**Subject: Response to NRC's Request for Additional Information on US-APWR
Topical Report MUAP-07009-P, "Thermal Design Methodology"**

**US-APWR Topical Report MUAP-07009-P,
"Thermal Design Methodology"**

Response to the NRC Request for Additional Information on
"THERMAL DESIGN METHODOLOGY", MUAP-07009-P Rev.0

Figure TP-1-1 UO₂ thermal conductivity degradation with local burnup

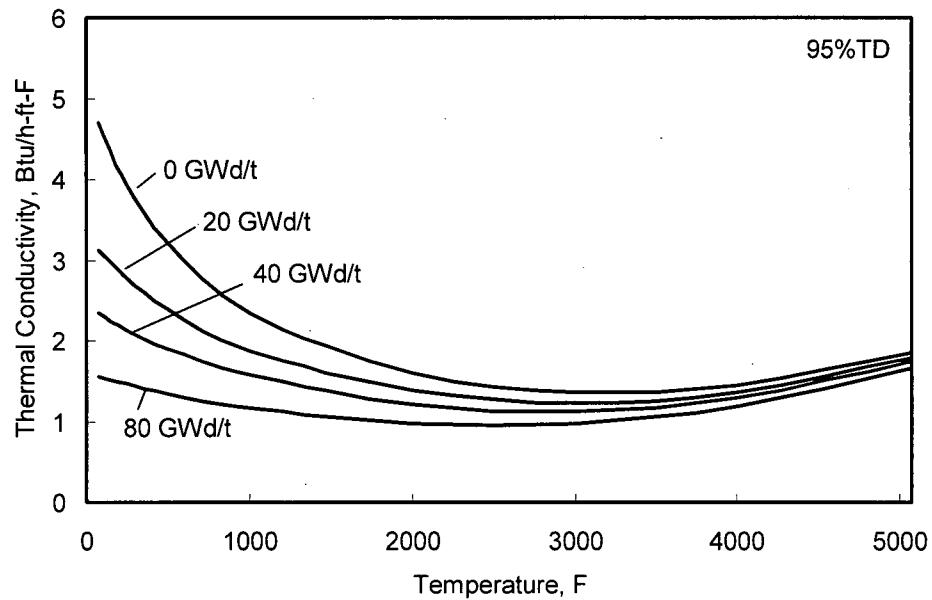
TP-1. It is stated in this section that a degradation effect, due to burnup, is applied to the thermal conductivity. Please describe the burnup degradation model and provide results of analysis of the effect at various burnups up to the limiting fuel burnup.

The fuel thermal conductivity that takes into consideration the degradation effect due to burnup is explained in page D-1 of Appendix-D. Figure TP-1-1 illustrates the burnup effect on the fuel conductivity.
